Blair Creek Stream Mitigation Project

Year 1 (2022) Monitoring Report FINAL

Response to DMS Comments (January 19, 2023) for DRAFT Monitoring Year 1 Report.
Blair Creek Stream Mitigation Project, Clay County
Hiwassee River Basin: 06020002
DMS Project #100047 DEQ Contract #7415

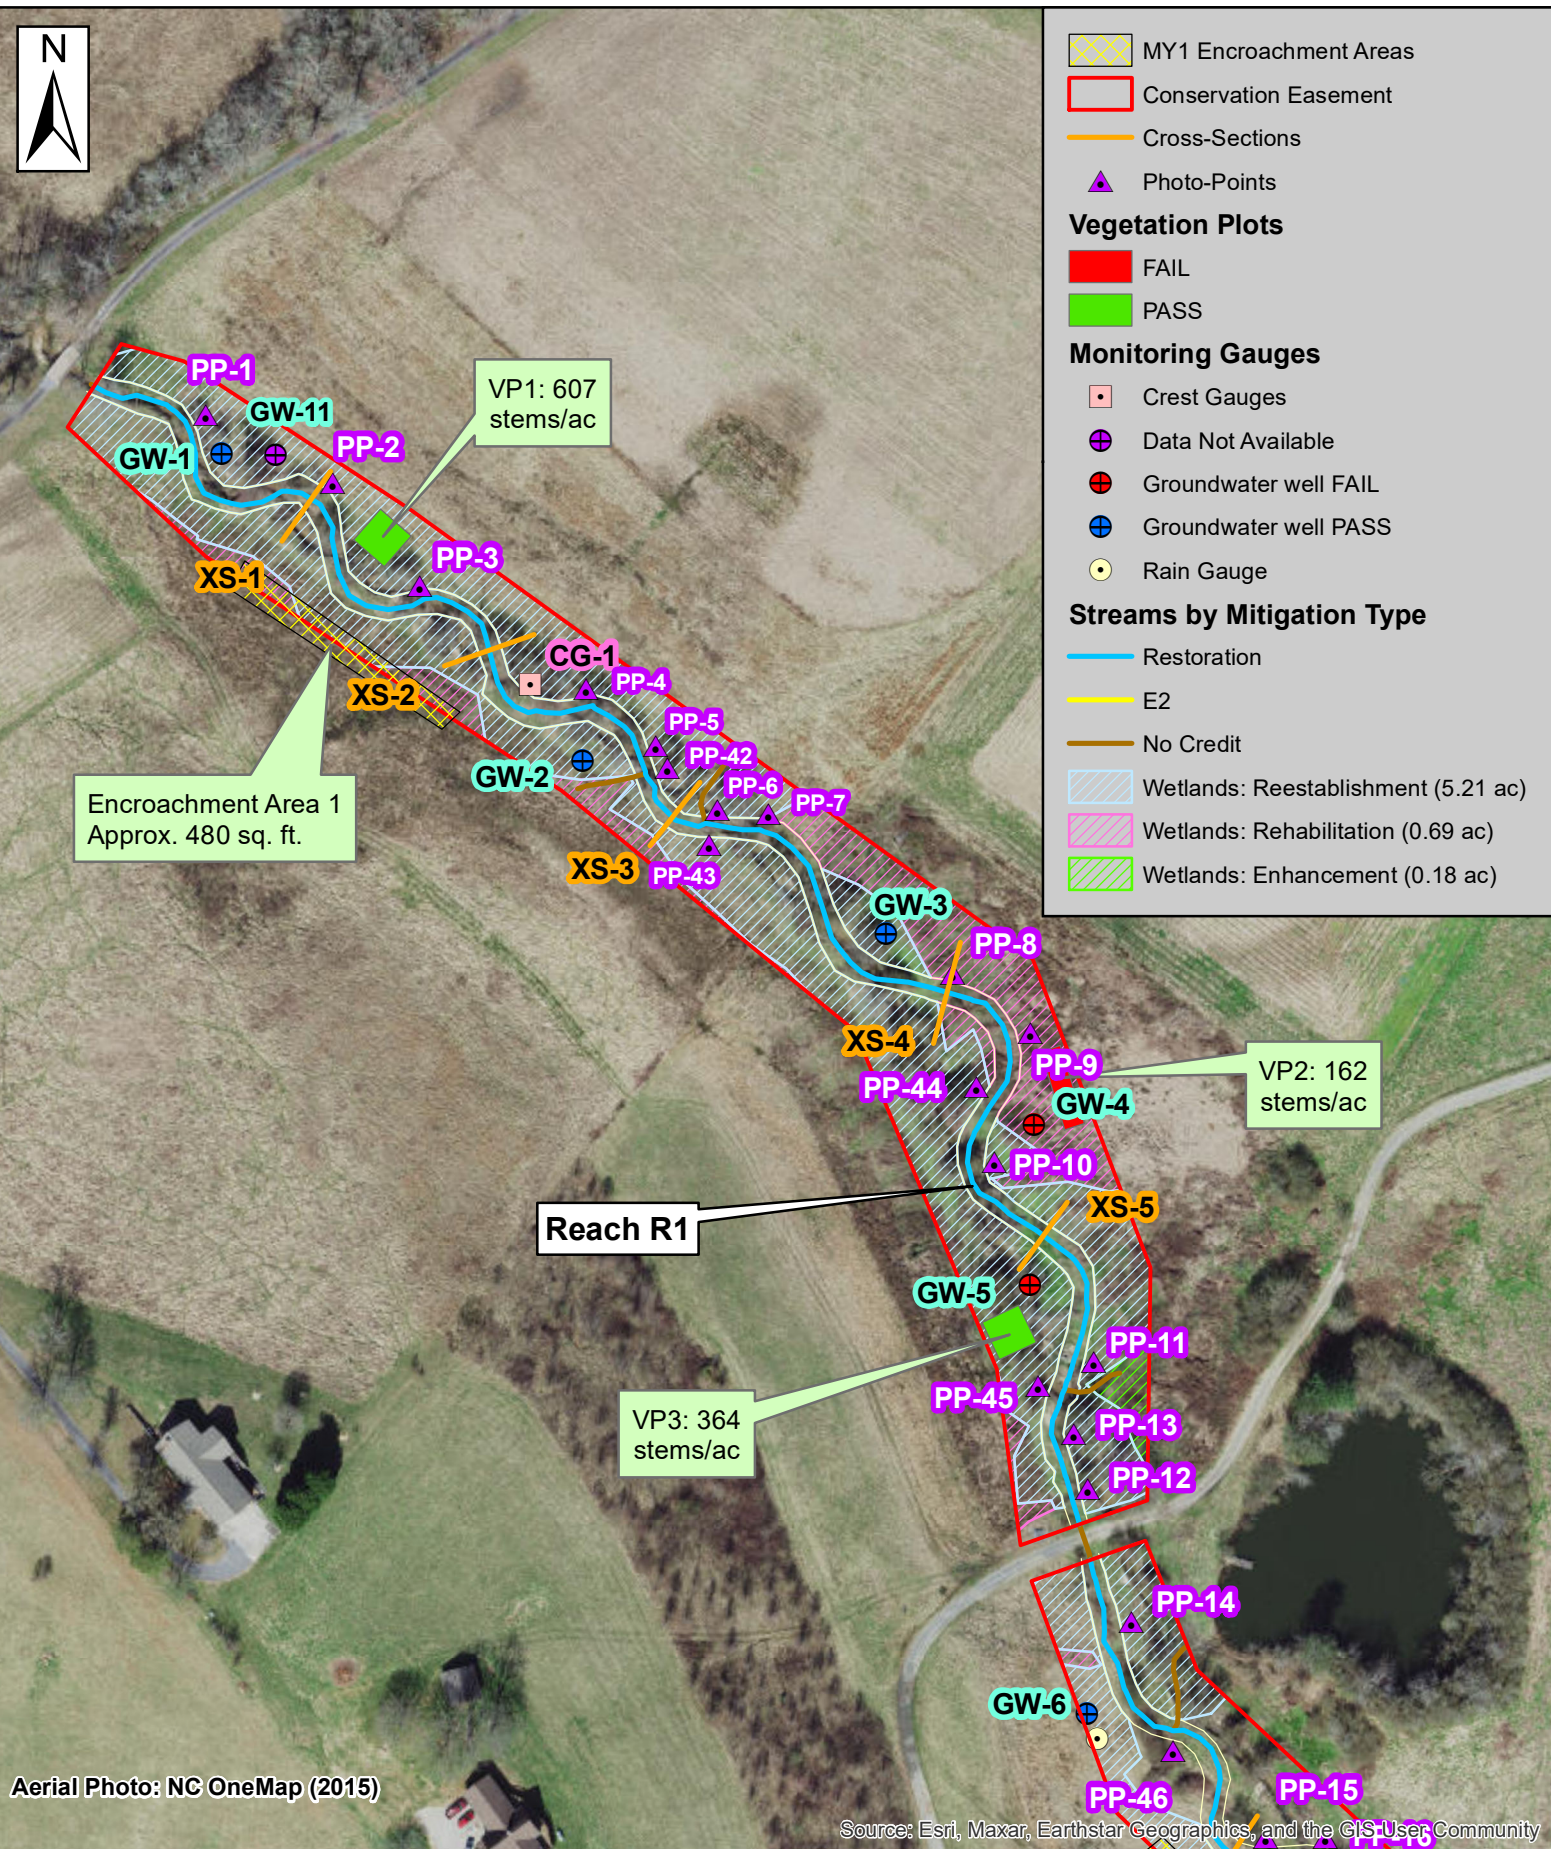
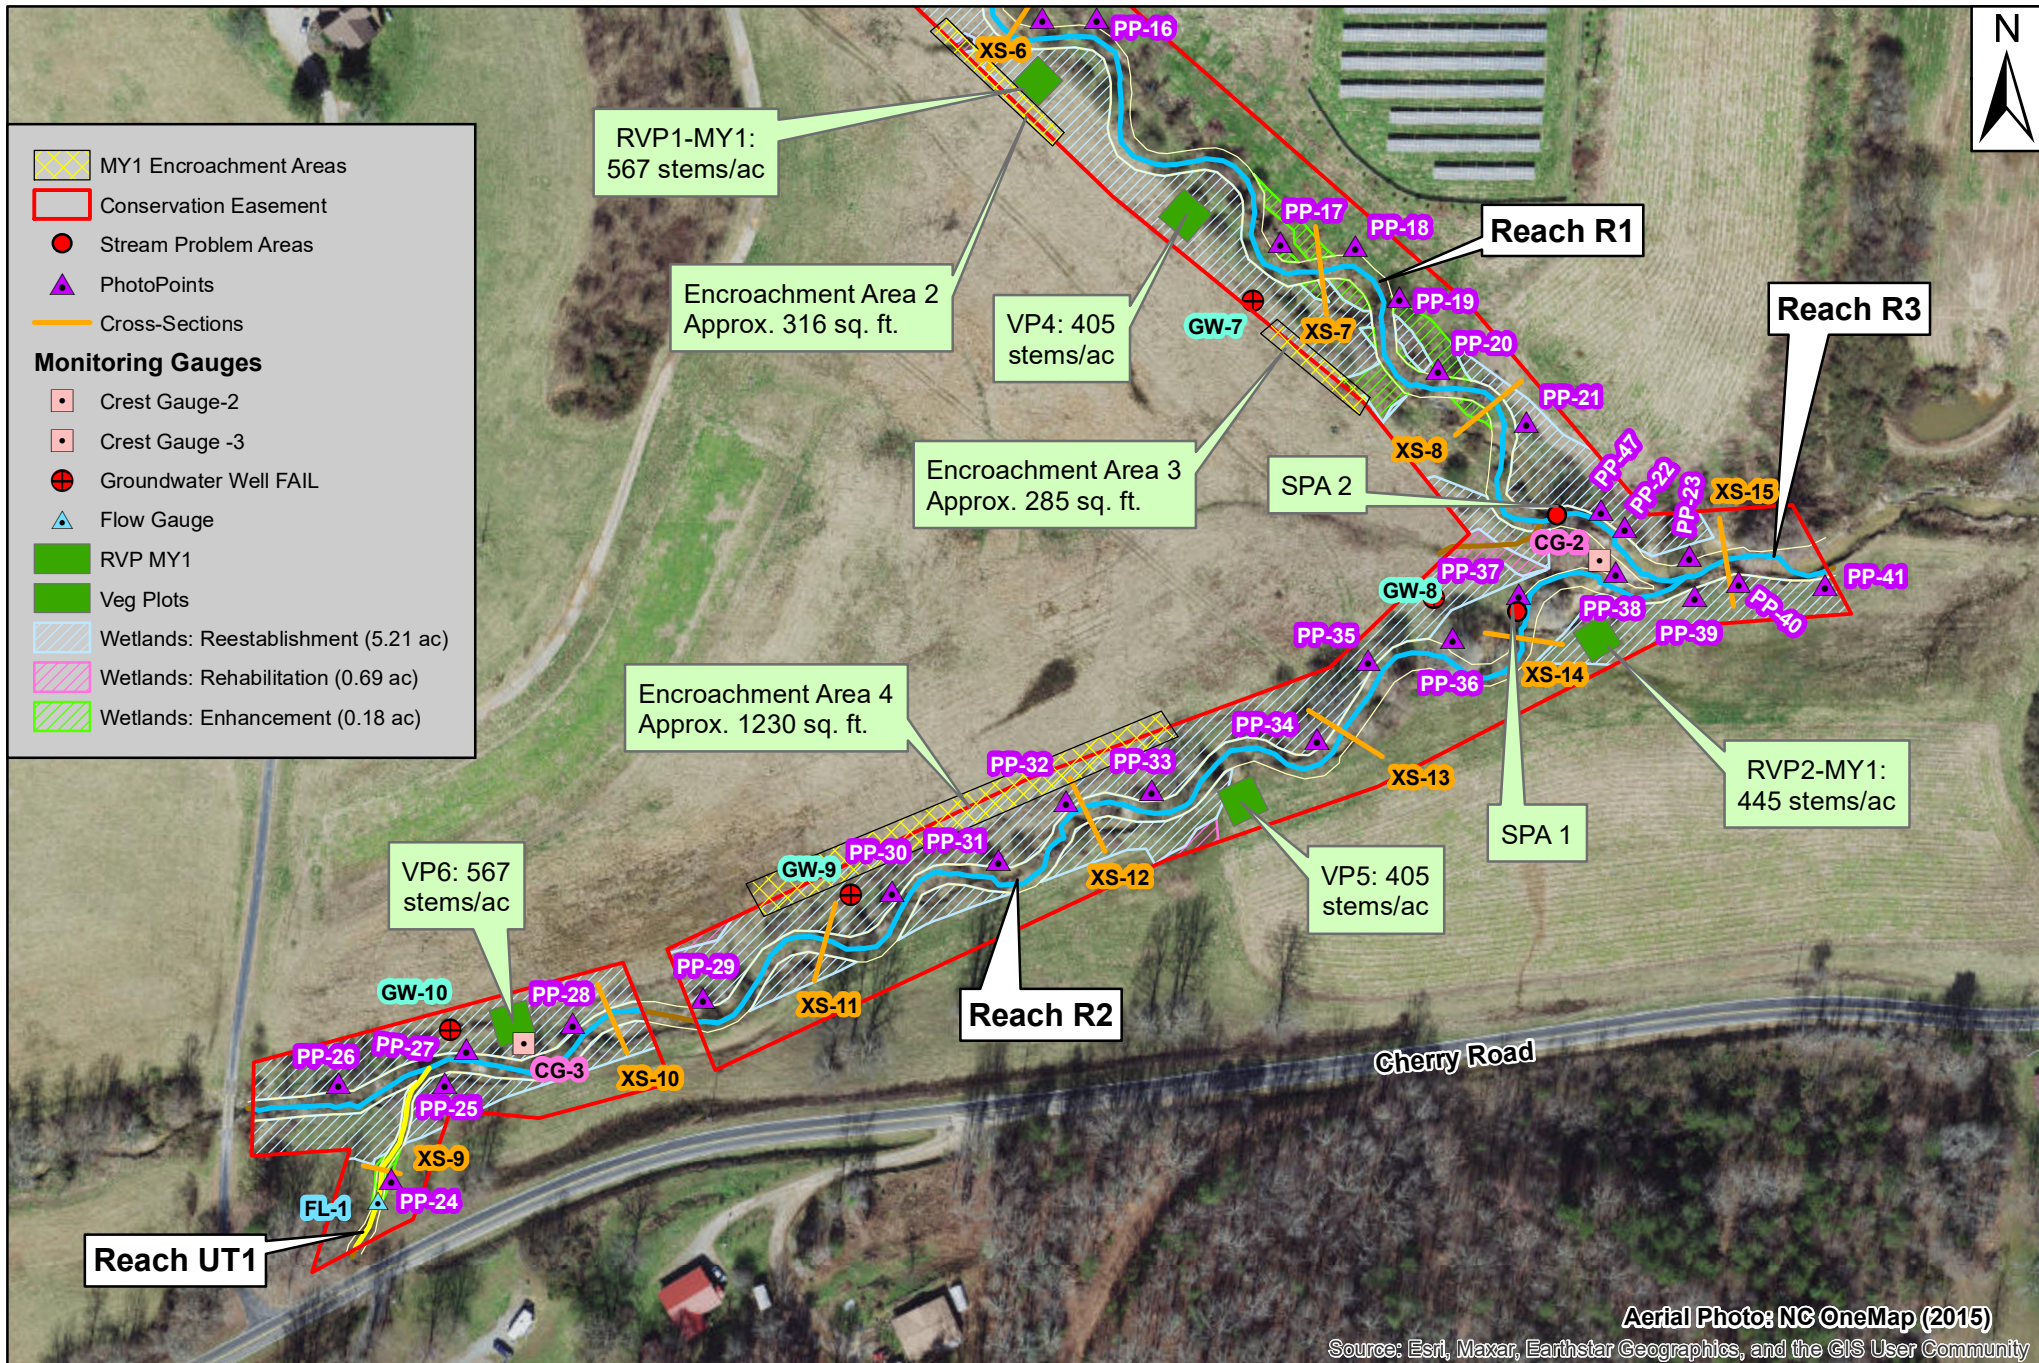
- CCPV: Please update color codes for vegetation plots, wetland gauges, and flow gauges for meeting/not meeting criteria.

- It was noted in MY0 that GW-1 was installed in a non-representative area for the surrounding wetland reestablishment area. Baker committed to moving the gauge approximately 15-20' farther away from the channel. The gauge location shown on the CCPV appears to be the original location. Please verify that the gauge was moved and update the CCPV accordingly.

- Table 5 and 6: Please include assessment dates at the top of each table.
RESPONSE: Assessment dates have been included as requested.
- Table 5 Reach 1: A 15' aggradation segment and 25' scoured/eroding segment is called out for this reach. These locations should be identified on the CCPV. Please update and include .shp files with digital submission as well.

RESPONSE: Vegetation plots, wetland gauges, and flow gauges have been color coded for meeting/not meeting criteria. The color of FL-1 or Flow Gauge 1 has not changed as it met criteria and is the only flow gauge on site.

RESPONSE: GW-1 was not moved; however, an additional well (GW11) was installed in a more representative location during MY1. The installation did not take place until late in the 2022 growing season, therefore data was not reported in MY1. All future monitoring years will include GW1 and GW11 data. The location of GW11 is shown on the CCPV. The photo below shows GW11 and GW1 is visible in the background.

RESPONSE: The 15' aggradation segment has been added to the CCPV as requested. The 25' scour/eroding segment is located on Reach 2 and is represented on the CCPV as SPA-1. These shapefiles have been included with the digital submission as requested.
